Product Change Notification

Change Notification #: 113210 - 00
Change Title: Intel® Server System R2208GZ4GC
PCN 113210-00, Product Design
Update Resistors and Capacitors
Date of Publication: August 18 2014

Figure 1. Component Locations for the 2U Riser Spare A2UL8RISER

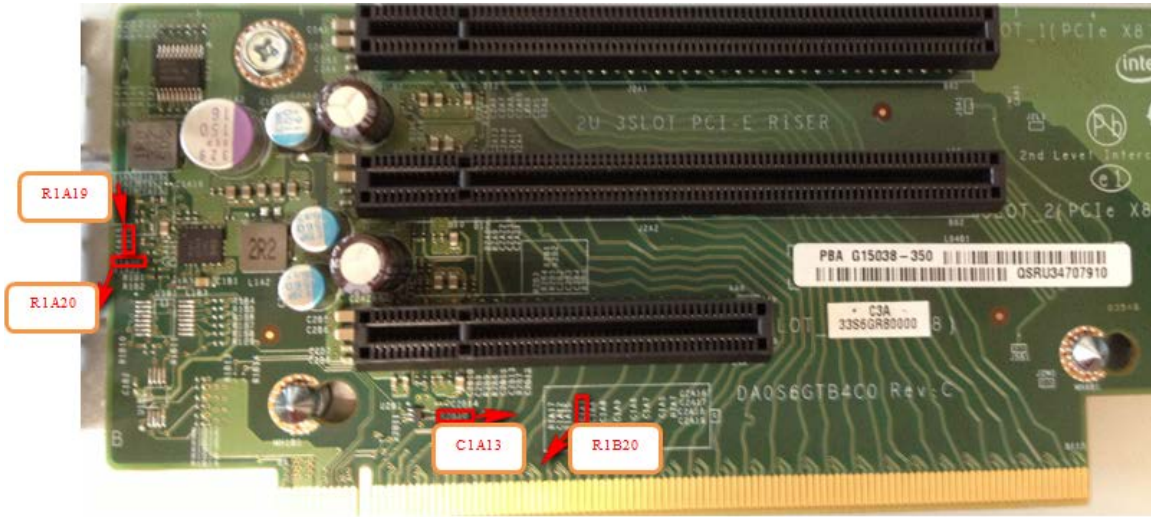
Update the following resistors and capacitor (see Table 1 and Figure 1) on the 2U PCIe Riser Spare A2UL8RISER to make an improvement to support a higher 3.3 Voltage Regulator startup over current. Before this change, the Voltage Regulator on the riser card may not be able to turn on when the total current drawn is more than 5A current. After this change, the Voltage Regulator on the riser card can support more than 10A current.

Component	Location	Pre-change	Post-change
Resistor	R2B10	10.0 kOhm	3.65 kOhm
Resistor	R1A20	0 Ohm	30 Ohm
Resistor	R1A19	40.2 kOhm	20 kOhm
Capacitor	C1A13	10 pF	120 pF
